Attachment B – Internal Council Referrals – EIS for 270 Horsley Road, Milperra – SSD-51147710

Urban Planning and Policy

To: Hannah Painter
From: Preetha Kumar
Date: 19 September 2023
Subject: 270 Horsley Road, Milperra – Traffic Comments – Proposed Multi-level Industrial Development

c. Turning path of 19m semi-trailer

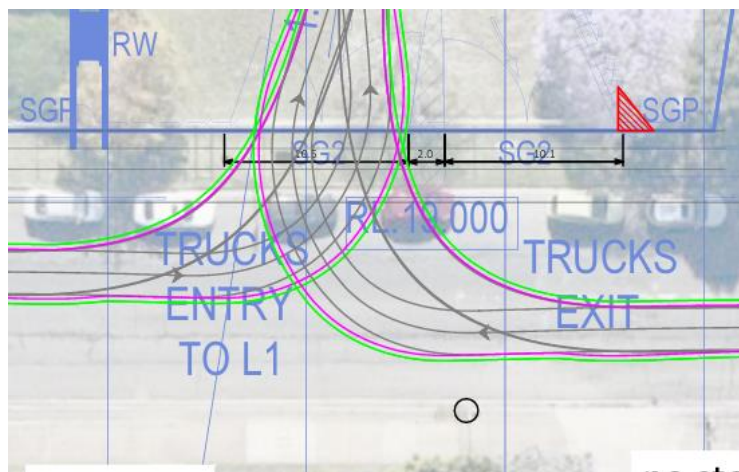
The Applicant is to provide turning path of truck turning right from Bullecourt Avenue into Horsley Road.

Figure 4 Ground Level showing proposed waste storage areas

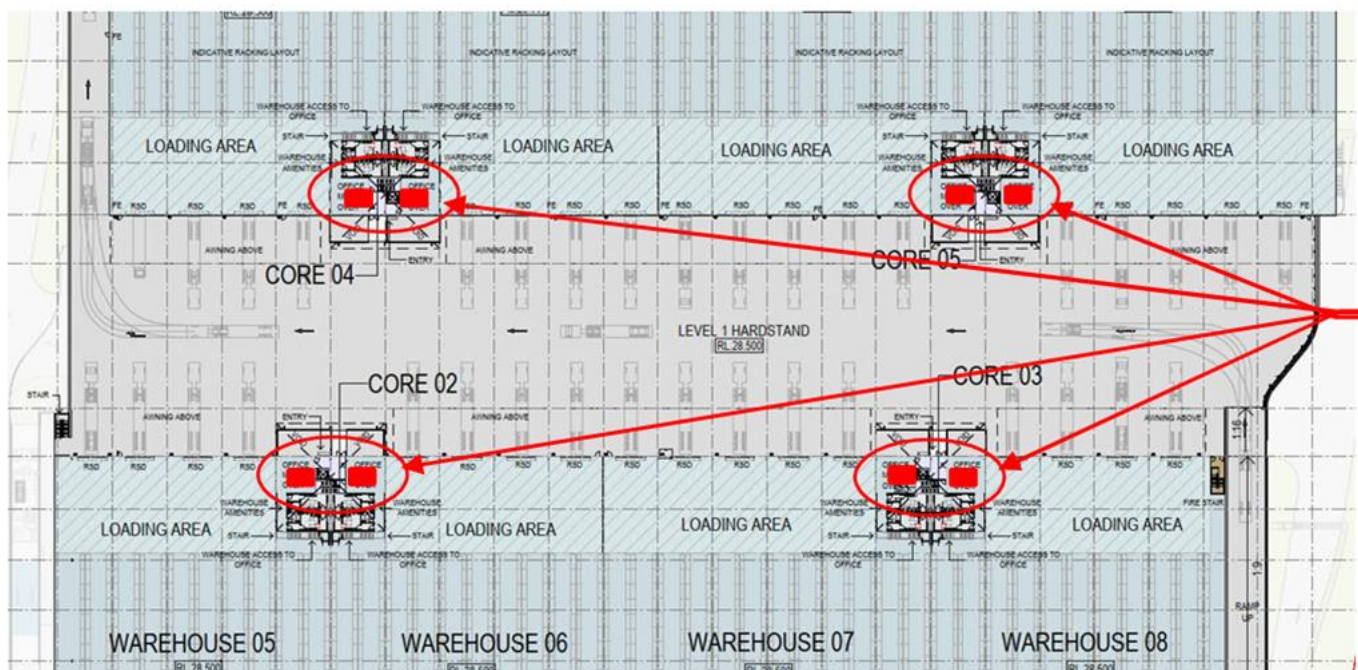
It might be good to get clarification on where the offices are going if they are converted into waste storage areas. Only the WMP talks about these areas being converted into storage areas. I've attached images of this discrepancy below
